Docket Item # 4
BAR CASE #2008-0190

ISSUE: Signage / Awning Installation
APPLICANT: Hector Velasquez (Choi Ki, Owner)
LOCATION: 1016 King Street
ZONE: KR / King Street Urban Retail Zone

Existing Conditions

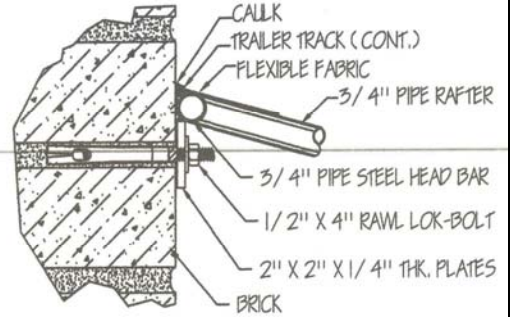
The Applicant is proposing to mount the awning to the building by utilizing bolts installed into the mortar joints in the form-stone veneer. As it is very difficult to detect the location of the original

brick façade's mortar joints underneath the veneer, it is likely the applicant will be boring holes into this original historic façade. This is a concern from a preservation perspective; however, there is not an easy solution to prevent damage to this historic fabric, short of removing the form-stone. As such, this application should be supported by the Board with the knowledge that if a future Applicant requests to remove the form-stone veneer and return the building's facade to its original period of construction, it is likely the rehabilitation specifications will contain language specifying removal and replacement in-kind for damaged bricks.

- F-1 The applicant shall obtain a sign permit for the proposed sign and/ or wall lettering.
- C-1 Canopies must comply with USBC 3202.3.1 for support and clearance from the sidewalk, and the applicable sections of USBC's Chapter 11. Structural designs of fabric covered canopies must comply with USBC 3105.3. The horizontal portions of the framework must not be less than 8 feet nor more than 12 feet above the sidewalk and the clearance between the covering or valance and the sidewalk must not be less than 7 feet.
- C-2 Canopies must comply with USBC 3105.1 and the applicable sections of USBC: Chapter 16. Structural designs of fabric covered canapés must comply with USBC 3105.3.
- C-3 A building permit is required for this project. Plans shall accompany the permit application that fully details the construction.

Staff recommends approval of the Certificate of Appropriateness as submitted.
